Comments: CDNR Comments on GMUG Working Draft Forest Plan

RE: Grand Mesa, Uncompahgre, and Gunnison National Forests Plan Revision - Working Draft Revised Land Management Plan

RE: CPW Comments Grand Mesa, Uncompahgre, and Gunnison National Forests Working Draft of the Revised Land Management Plan (June 2019)

Figure 2. Post-hunt population estimates and observed calf:cow ratios from 1980-2018 on the Uncompahgre Plateau (DAU E-20).

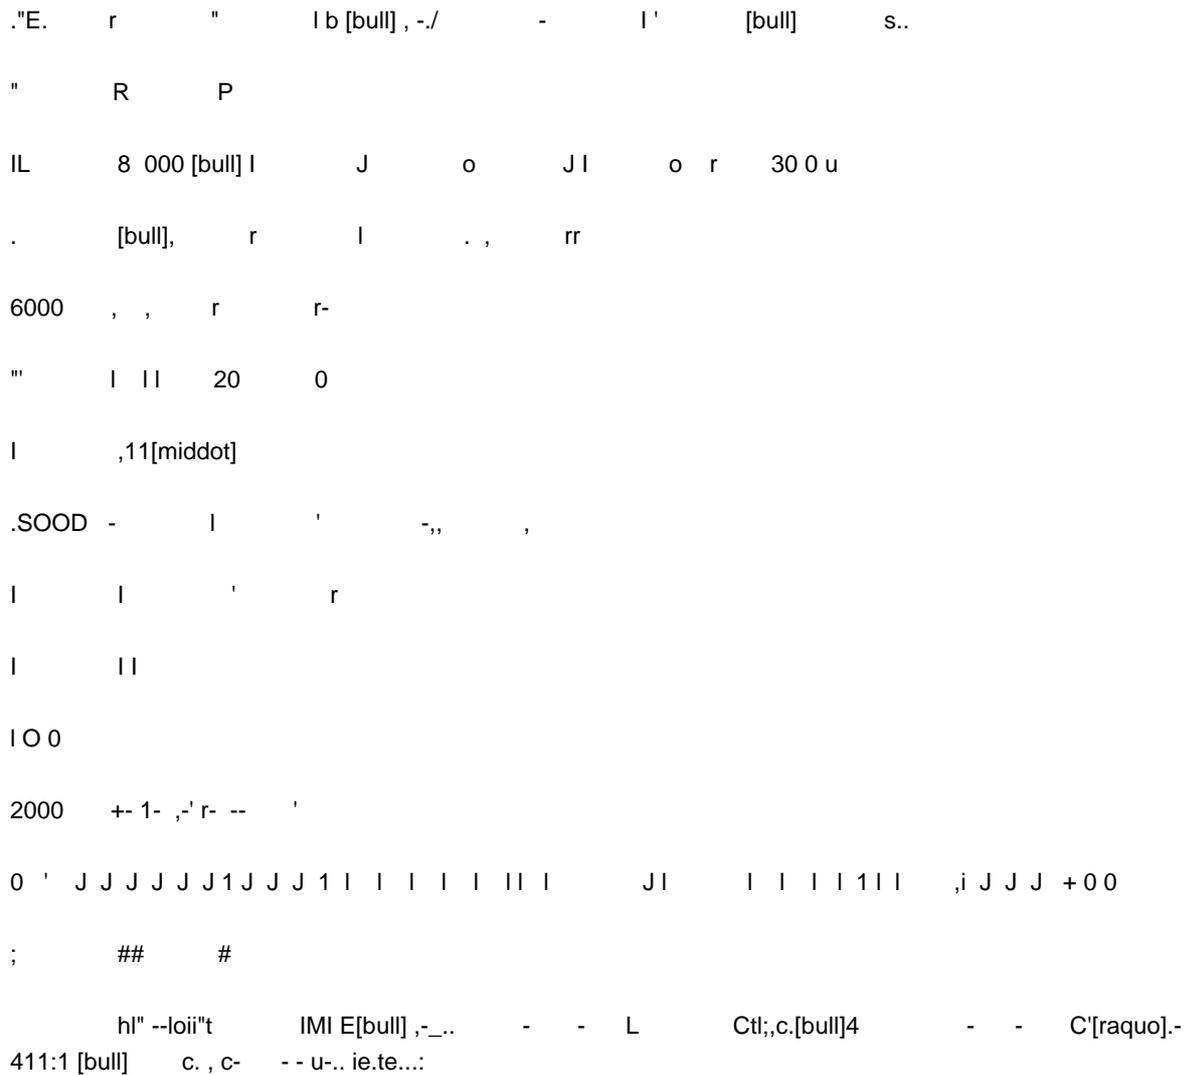
Figure 2 illustrates the growth and then decline in elk population since 1980. It also illustrates that the calf recruitment, indicated as calf /cow ratio, has continued to decline.

Due to the population declines and low recruitment of juvenile deer and elk into the population, the numbers of deer and elk licenses have been reduced over the years. The decline in population numbers is associated with the drought impacts over the last 20 years, loss of habitat to development, predation, competition for quality forage between deer, elk, and domestic grazers, and increased recreation forcing animals to lower quality habitat and onto private lands.
